**Service Manual AE 6890**

## Technische Mitteilung zu AE 6890

## Technical Information AE 6890

### Softwarebugs in Produktionen bis einschl. Dezember 2008

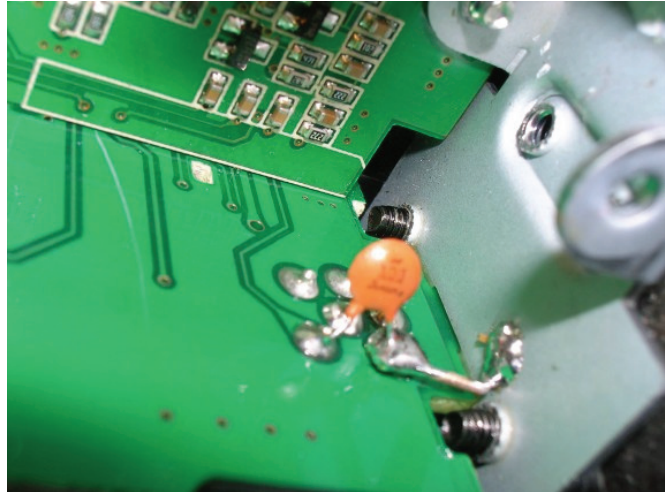
**Problem:** Bei Montage einer schlecht geerdeten Antenne oder einer Antenne mit schlechtem SWR sehr nahe am Funkgerät im LKW kann es vorkommen, dass das Sendesignal vom Mikrofonskabel aufgenommen wird und die Modulation gestört wird (das Ergebnis sind starke Verzerrungen in AM).

a) Antenne in Ordnung bringen

oder

b) **zusätzlichen Kondensator 103 = 10 nF bzw. 0.01  $\mu$ F** nach Bild direkt an der Mikrofonsbuchse zwischen Pin 1 und Masse einbauen

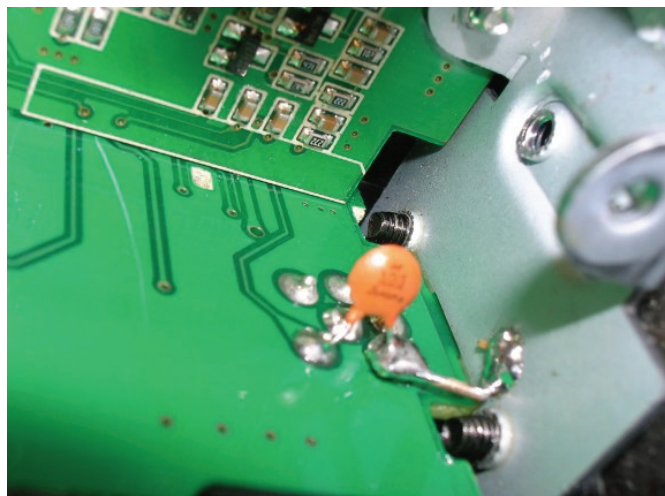
**Problem:** If the antenna is mounted in a truck installation very close to the radio, has a bad grounding or a bad SWR, it may happen that RF energy will be picked up by the microphone cable. The consequence can be a distorted modulation quality in AM.

a) install a correct grounded antenna and take care that the SWR is good

or

b) **add a capacitor 10 nF = 0.01  $\mu$ F** (printing 103) inside the radio as shown on the picture. The capacitor shall be soldered directly to pin 1 of the mic socket and ground as shown on the photo.
